ALTERNATIVE ASSIGNMENT OF SCENES to LABS and VIEWERS -
 Multiple Team Proposal (acm 2/3/98)

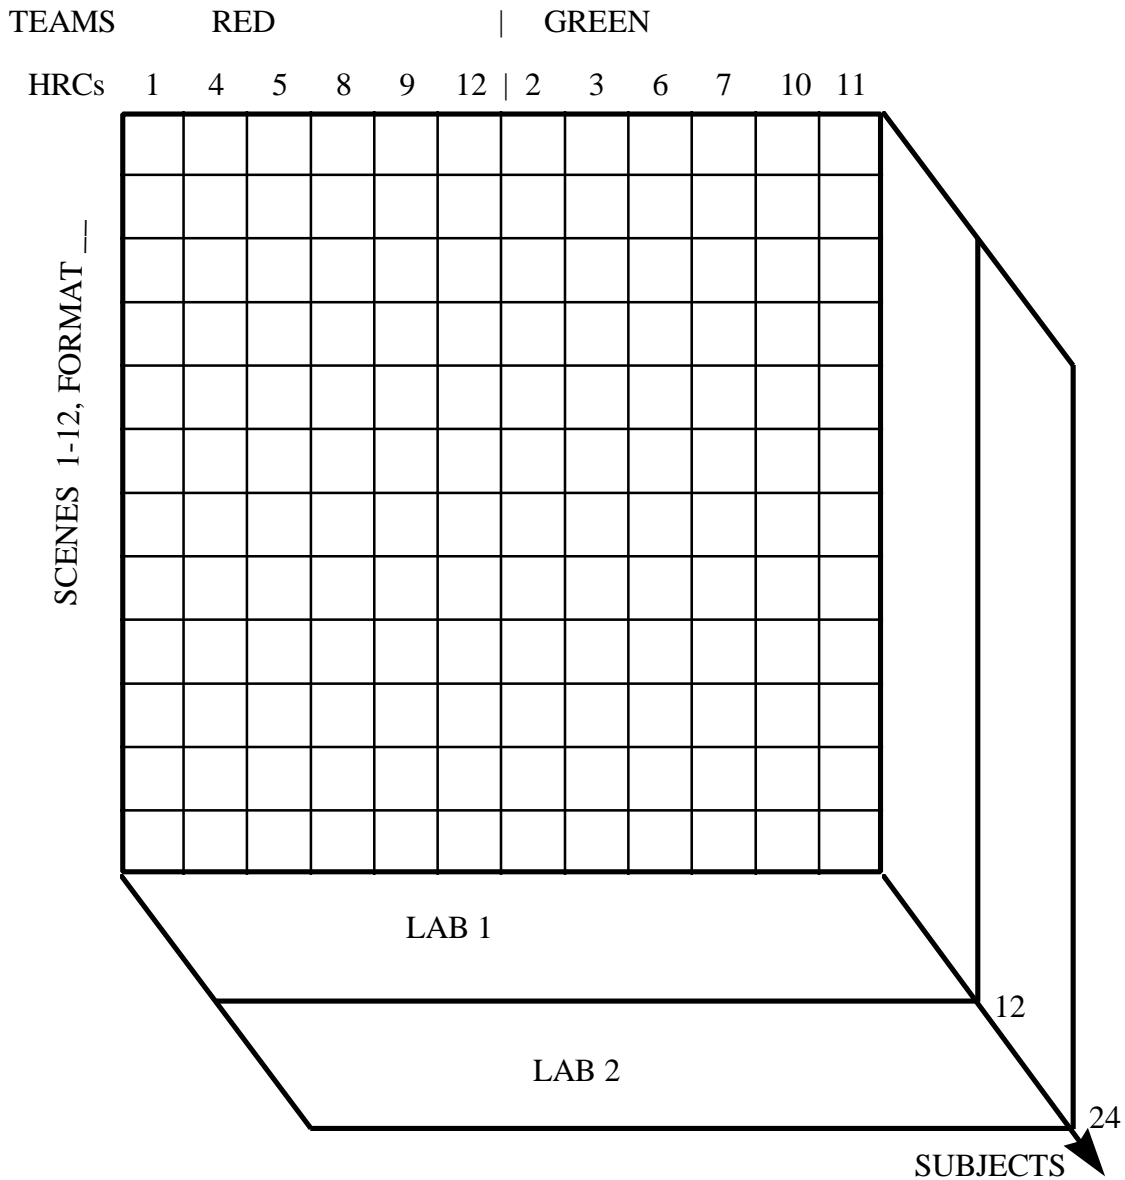
The figure below is a test design for one HRC range and one video format (12x12). The viewers at each lab are divided into teams, with each team seeing all scenes combined with a subset of HRCs. The HRCs are numbered by increasing quality, and divided among the Teams. A two-team design could be implemented as follows:

Each Lab randomly assigns viewers to teams as they are enrolled for the test, supplying 12 viewers per team. Each viewer would rate 72 scene-HRC combinations. This is close to

the 88 combinations given in section 2.4 of the current subjective test plan. As far as I can tell, this doesn't violate any of the ANOVA design criteria, but I encourage others to determine if this is true.

The main advantage of this approach is that any bias among ratings collected at a particular lab is distributed evenly over all combinations.

If HRCs are divided among labs instead of teams, any lab bias affects a subset of the results. Since the common conditions or HRCs used by all labs would be limited, they may not provide an adequate basis to identify or compensate for lab bias.

Administration of two different teams may be slightly more difficult for the labs, and possibly require production of more test tapes, but I believe the advantages outweigh these issues.
